**AGENDA**  
**CITY OF CEDAR FALLS, IOWA**  
**PLANNING AND ZONING COMMISSION**  
**WEDNESDAY, JULY 25, 2018**  
**5:30 PM AT CITY HALL - COUNCIL CHAMBERS**

TO: Planning and Zoning Commission
FROM: David Sturch, Planner III
DATE: July 18, 2018
SUBJECT: Highway 1 District Site Plan Review – Raising Cane’s

TO: Planning & Zoning Commission
FROM: David Sturch, Planner III
DATE: July 18, 2018
SUBJECT: Redevelopment of 6607 University Avenue

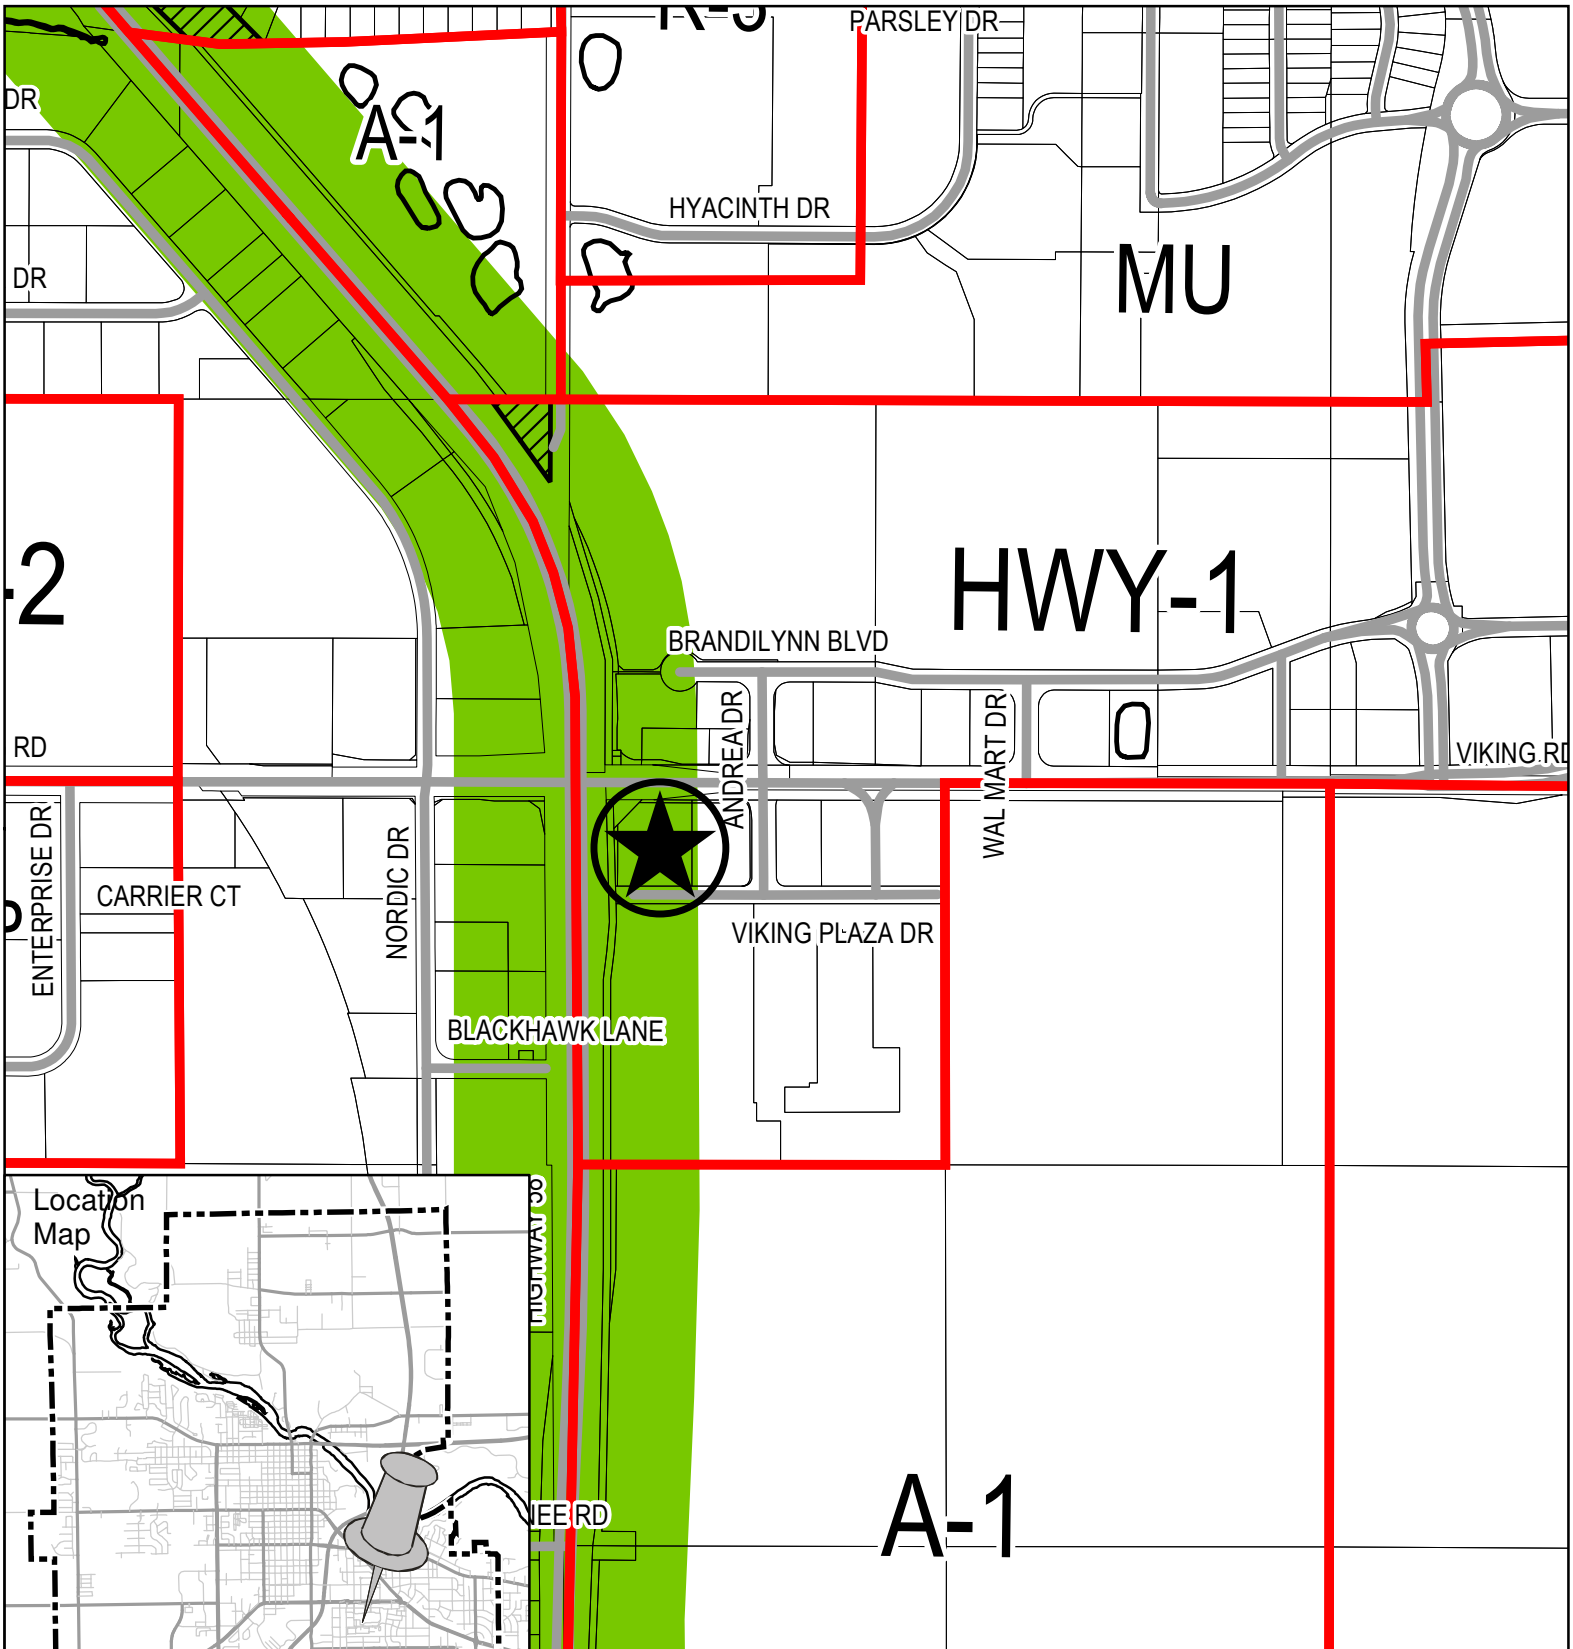
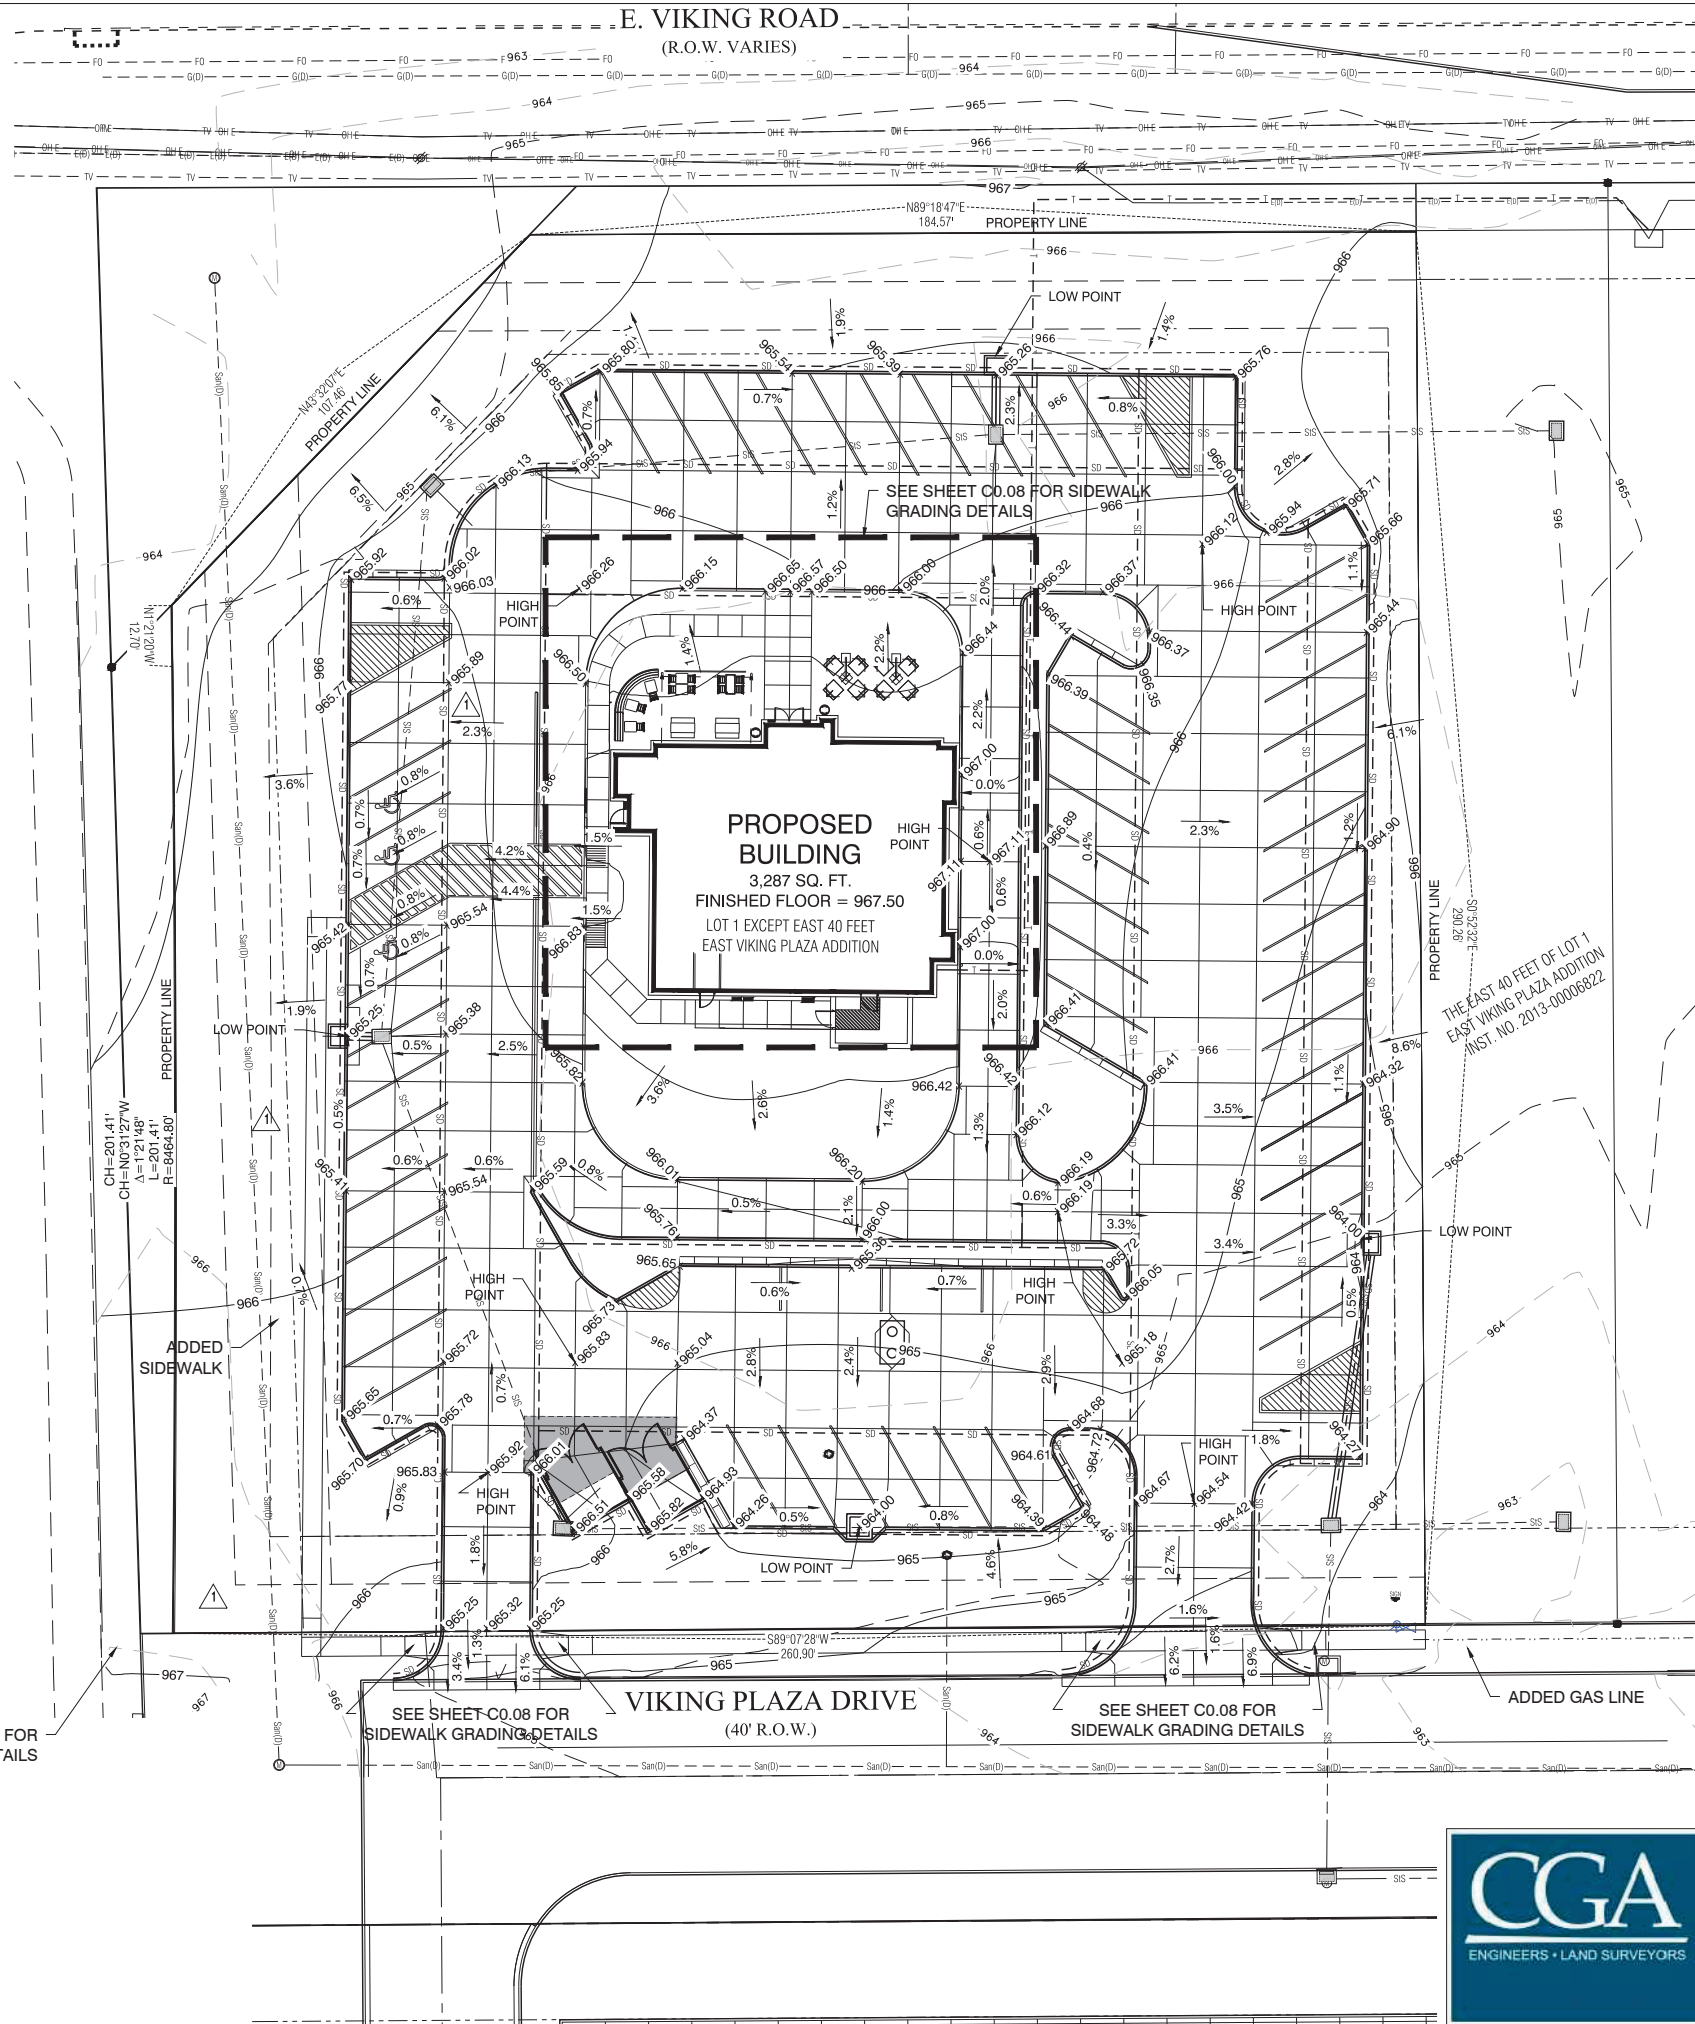
- 2) Setbacks: The setbacks apply to the building, parking lot and signage. The HWY-1 District requires a 20-foot setback around the perimeter of the "district" and 20 feet along the public streets. Since the perimeter of this lot is on the west side and public streets are along the north and south, the 20-foot setback applies to this property. There are no internal setbacks along the east lot line. The site plan depicts parking lot setback along the north lot line is 28 feet; 31 feet from the west lot line; 20 feet from the south lot line and 10 feet from the east lot line.

The proposed building is situated approximately 100 feet from the north lot line; 91 feet from the west lot line; 132 feet from the south lot line and 94 feet from the east lot line. The plan does not include a freestanding sign. The proposed restaurant will utilize some signage space on the existing tenant sign for the entire development. **Setbacks satisfied.**

- 3) Parking: The parking requirement must be calculated for the restaurant building. A standard fast food restaurant requires 1 parking stall for every 100 square feet of gross floor area, plus one additional parking stall for every two employees. The drive-up window on the east side of the building requires five stacking spaces. The proposed restaurant is approximately 3,300 square feet in area for a total of 33 parking stalls. The site plan illustrates the installation of 64 parking stalls including three handicap stalls, which exceeds the minimum requirement. Parking stall dimensions are provided (9' x 21') with driveway aisle widths are 24 feet. **Parking requirement satisfied.**

The Community Development Department recommends approval of the Raising Cane’s restaurant site plan subject to the following conditions:

- 1) Conformance with the technical comments identified in the staff report.
- 2) Any additional comments or direction specified by the Planning and Zoning Commission.

SITE PARKING PLAN  
TOTAL STALLS = 189

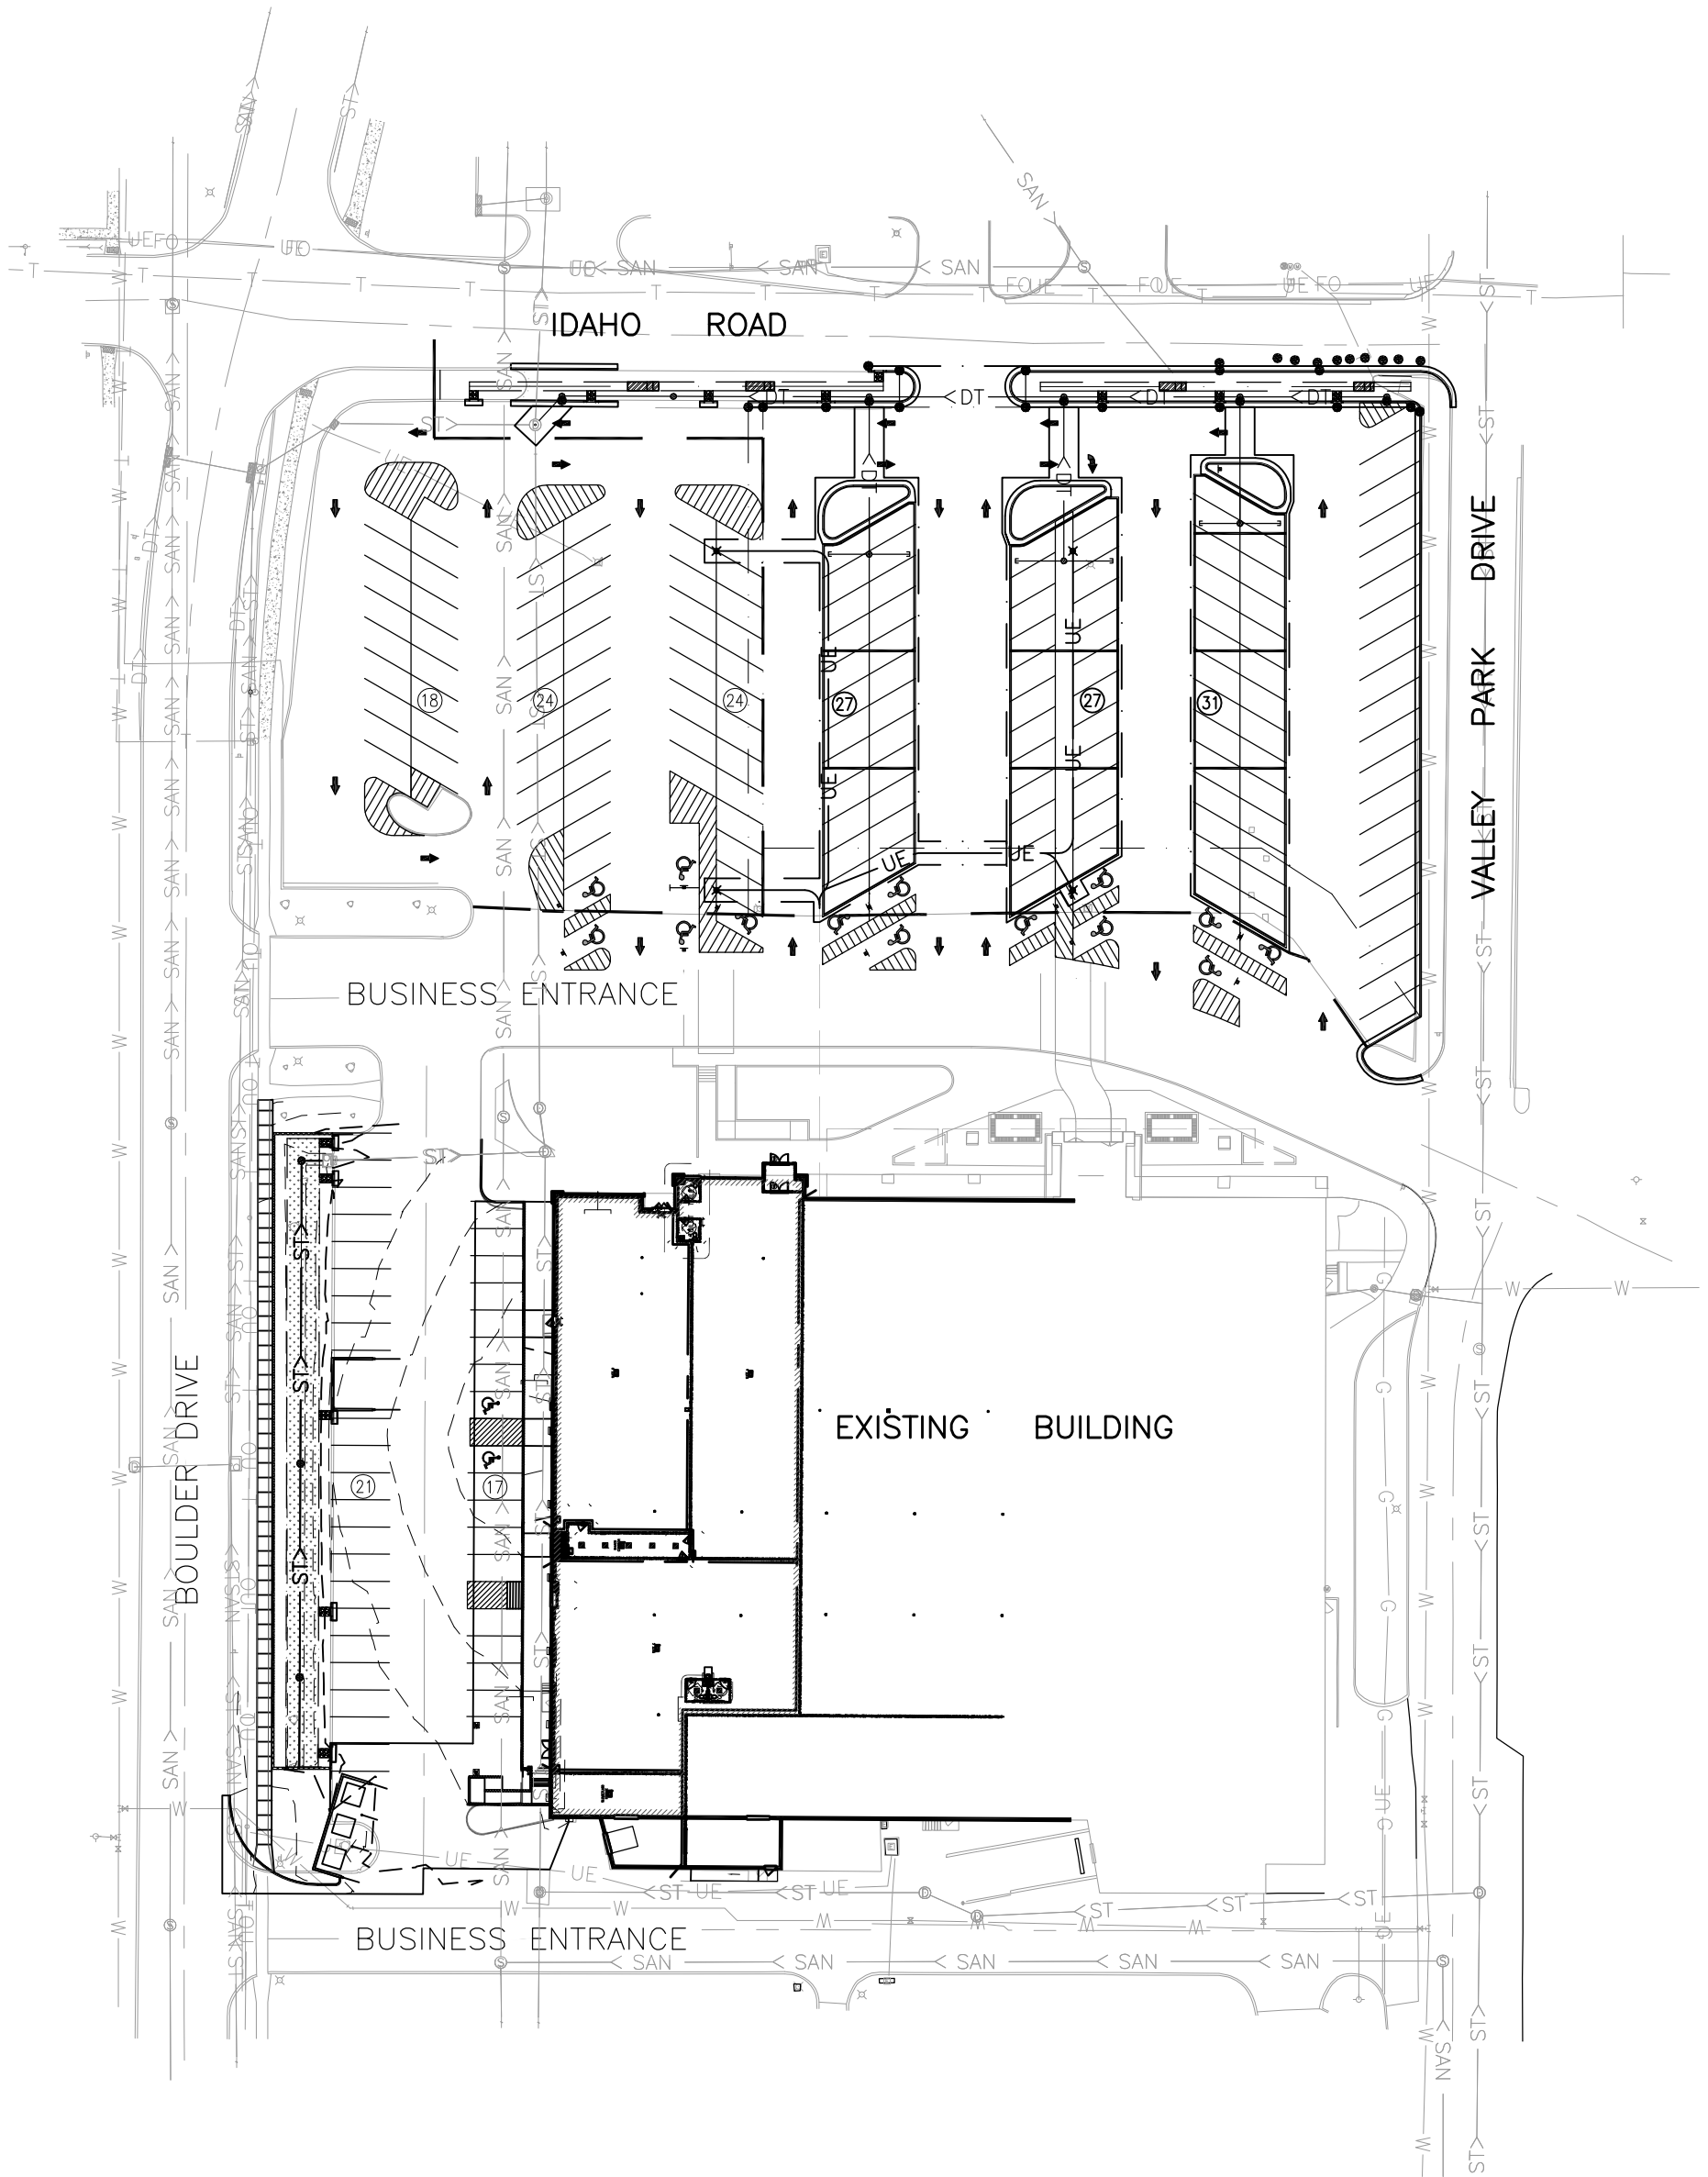
The building, according to the Black Hawk County Assessor, the building is 59,763 square feet. The following is a parking breakdown for each tenant space in the building.

Square Footage*	Use*	Employees*	Required	Provided
43,442	Furniture store	15	73	
5,320	Restaurant	10	40	
11,001	Retail stores	NA	50	
<b>59,763</b>			<b>163</b>	<b>189</b>
